Access Compliance Report

Public Rights-of-Way

Intersection ID: 9801	Main Street: ETHEL_GUEST_LN	Cross Street: RISING_OAK_DR	Location: SW
ADA ID: 6A4476751D55	Ramp Type: PerpDiag	Initial Pass/Fail: Fail	Overall Compliance: No
Severity Score: 60			
Codes/Mitigation Info/Possible Solution		Field Measurements/Component Compliance

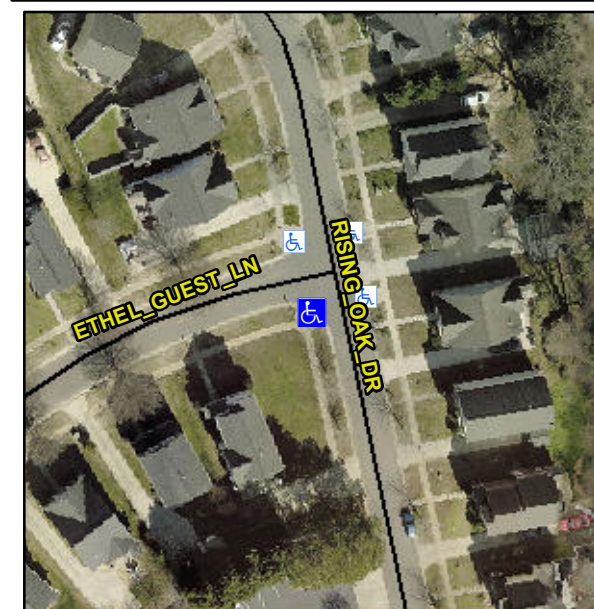
Not Found, R304.5.1, R304.5.3

Compliance	Description	Data	Compliance	Description	Data
N/A	Ramp Length (in)	93.0	Yes	Ramp Slope (%)	5.7
No	Ramp Width (in)	26.5	No	Ramp XSlope (%)	7.4
N/A	Flare Type LT	N/A	N/A	Flare Type RT	N/A
N/A	Flare Slope LT (%)	N/A	N/A	Flare Slope RT (%)	N/A
N/A	Flare Traversable LT?	N/A	N/A	Flare Traversable RT?	N/A
N/A	Landing Length (in)	N/A	N/A	DWS Provided?	N/A
N/A	Landing Width (in)	N/A	N/A	DWS Contrast?	N/A
N/A	Landing Slope (%)	N/A	N/A	DWS Length (in)	N/A
N/A	Landing X Slope (%)	N/A	N/A	DWS Full Width?	N/A
N/A	Landing Curb? (Y/N)	N/A	N/A	DWS Offset (in)	N/A
N/A	Shared Landing?	N/A			
N/A	Gutter Ponding?	N/A	N/A	Gutter Slope (%)	N/A
N/A	Gutter Lip Ht (in)	0.5	N/A	Gutter X Slope (%)	N/A
N/A	Painted X Walk1?	No	N/A	Painted X Walk2?	No
	X Walk 1 Direction	To E		X Walk 2 Direction	To N
N/A	X Walk 1 Width (in)	N/A	N/A	X Walk 2 Width (in)	N/A
	X Walk 1 Slope (%)	3.7		X Walk 2 Slope (%)	4.8
	X Walk 1 X Slope (%)	2.3		X Walk 2 X Slope (%)	2.0

Remove & Replace Curb Ramp With Two New Directional Ramps or Equivalent.
